From: Dave Seller
Sent: Thursday, April 27, 2023 9:17 AM
To: Craig Dumart
Subject: UPDATED: OPA/ZBA comments: 97-101 Park St & 186 -194 & 200 Victoria St S

Application Type: Official Plan Amendment Application OPA23/003/V/CD
Zoning By-law Amendment Application ZBA23/007/V/CD

Project Address: 97-101 Park Street and 186 -194 & 200 Victoria Street South

**Re: Proposed Official Plan Amendment OPA 23/03 and
Zoning By-law Amendment ZBA 23/07
97-101 Park Street and 186-200 Victoria Street South
Arcadis IBI Group (C/O David Galbraith) on behalf of
1928393 Ontario Inc.
CITY OF KITCHENER**

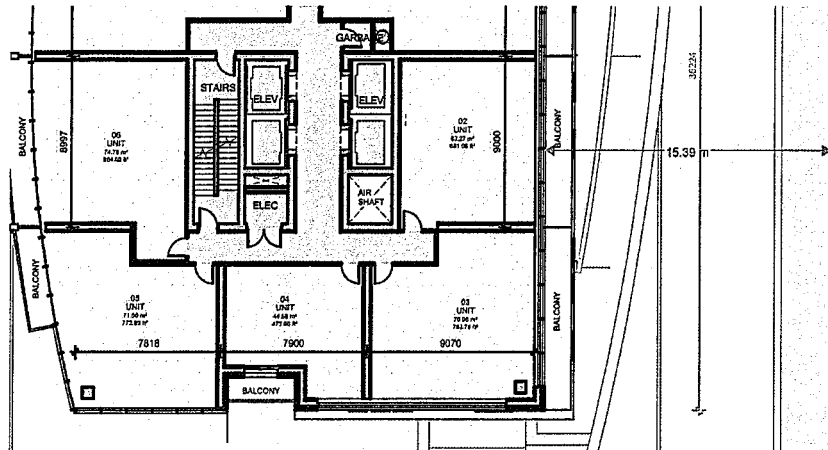
While the concept of residential intensification on this site is positive, and many previous staff comments have been incorporated into the proposal, some design modifications must be addressed in the Site Plan Application to create a development proposal that is well-designed and appropriate for this site and neighbourhood.

Tall Building Design Analysis: The proposal needs to fully meet the tall building guidelines, specifically with regard to separation, as the guidelines are an excellent compatibility test for proposals exceeding their zoning permissions. The tower separation distance for the proposed tower is estimated to be 23m. Off-site separation on the east side is important in this context, where the site abuts low-rise residential planned for future development. The applicant shall prepare an updated urban design brief demonstrating that adequate off-site tower separation and adequate on-site amenity space are provided to the satisfaction of the City of Kitchener.

- The proposed tower separation of 19m from levels 14-42 on page 29 urban design brief does not match the proposed setbacks on the submitted architectural package. Design modifications should be provided to meet the required off-site separation.
